ADDENDUM NUMBER: Five (5)

TITLE: Construction Services for Ponte Vedra Wastewater Treatment Facility

SOLICITATION NUMBER: 1412137046

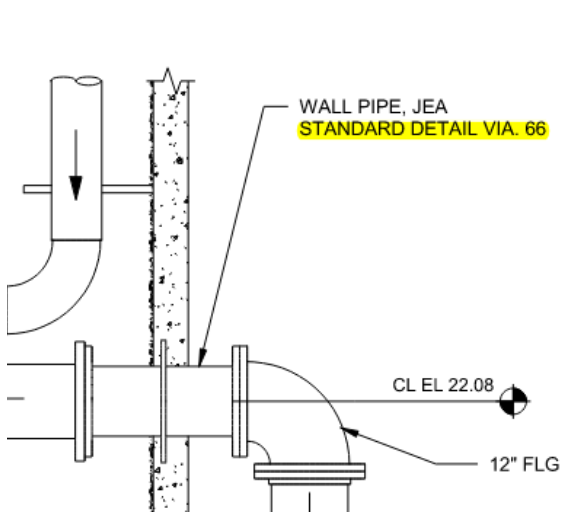
- Answer:** JEA confirms this.
26. **Question:** Please provide the size and/or design live load (in pounds per linear foot) for the davit crane shown on the prestressed Post Equalization Tank Drawing M5.0, and confirm whether the walkway should be designed to support one or two davit cranes.

- Answer:** Crane size can vary depending on manufacturer, walkway to be designed to support one davit crane.

VIA.66 FLOOR/WALL PIPE
NTS

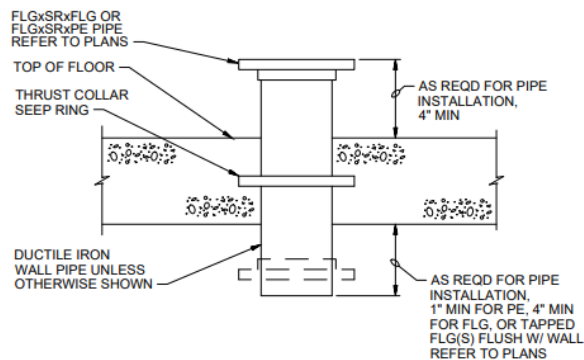
29. **Question:** Please advise where to find the detail referenced below. I have looked on the JEA website and cannot find any detail VIA 66 or Detail 66.

Answer: Please refer to 2025 JEA WRF Standard Details Vol 6A, page 31.
